From: Gonzales, Rafael [mailto:rjgonzales@STPEGS.COM]
Sent: Thursday, May 04, 2017 10:11 AM
To: James, Lois <Lois.James@nrc.gov>
Cc: Aldridge, Arden J <ajaldrige@STPEGS.COM>
Subject: [External_Sender] STP response to ACRS questions

Below are responses to the questions from the ACRS subcommittee meeting:

Availability of Cathodic Protection System in the Protected Area

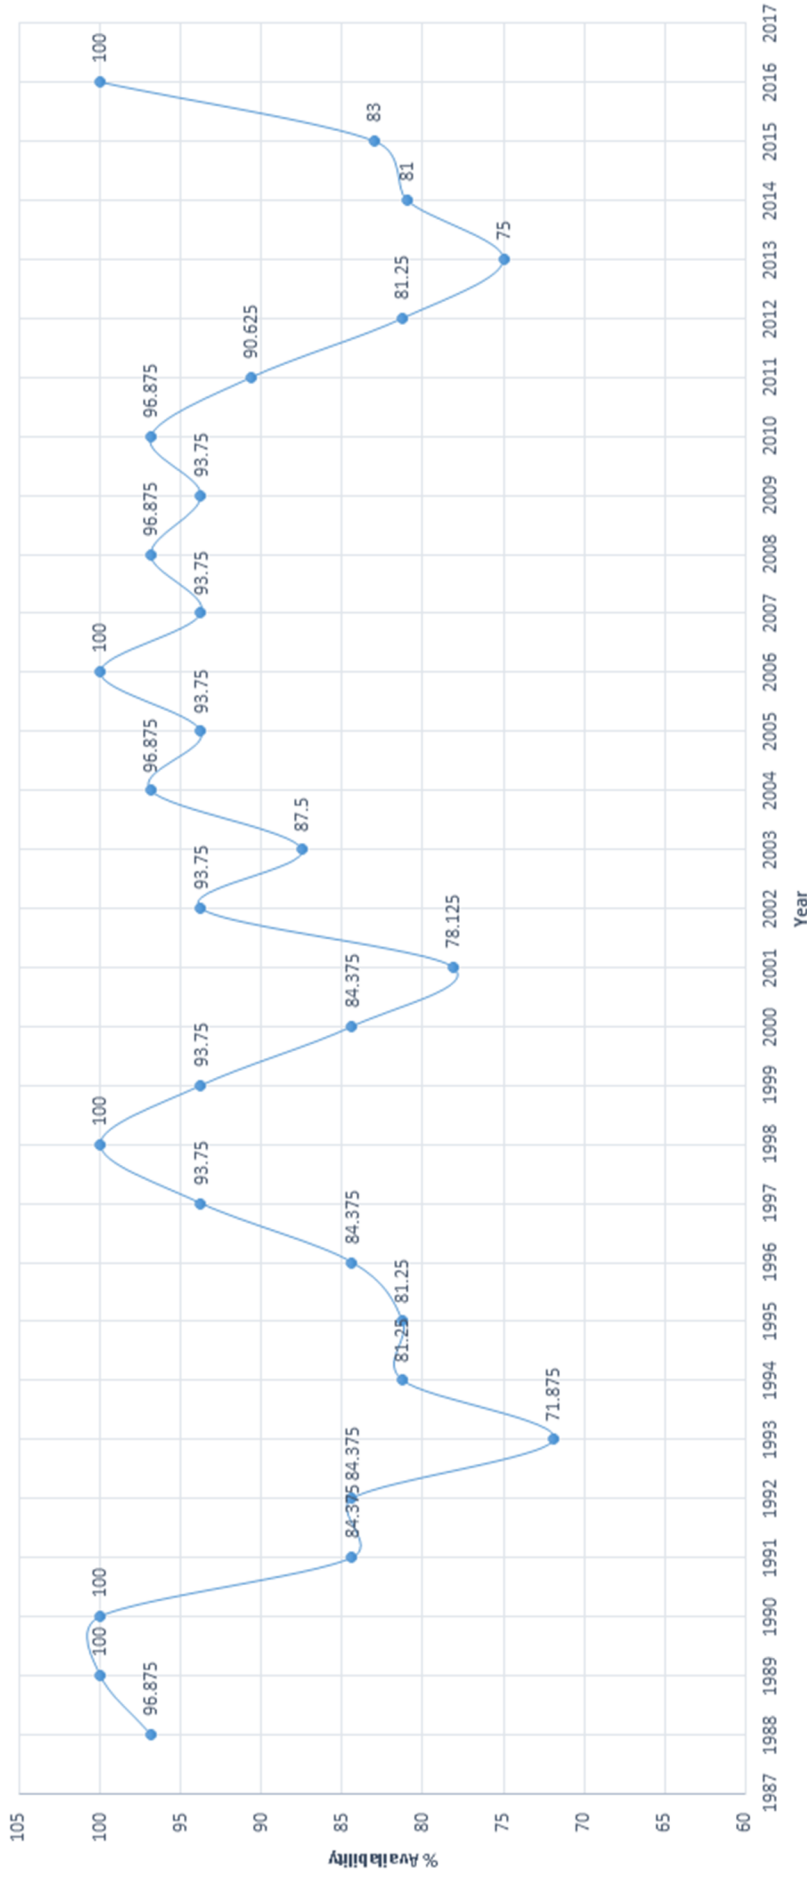
Question 1: (ACRS Member Stetkar) What has the historic availability over the life of the plant of you cathodic protection system been?

The historical availability over the life of the plant of you cathodic protection system is as follows:

For the years 1988 to 1993, the data has been obtained from the preventive maintenances performed on all 16 rectifiers installed in the protected area. For the years 1994 to 2016, the data was obtained from 2 annual preventive maintenances (i.e. 93001319 and 94002738) performed on the system rectifiers to adjust/repair and pipe-to-soil potential surveys. It is best to consider the availability by individual year but the system maintained a lifetime average of 89.6% availability.
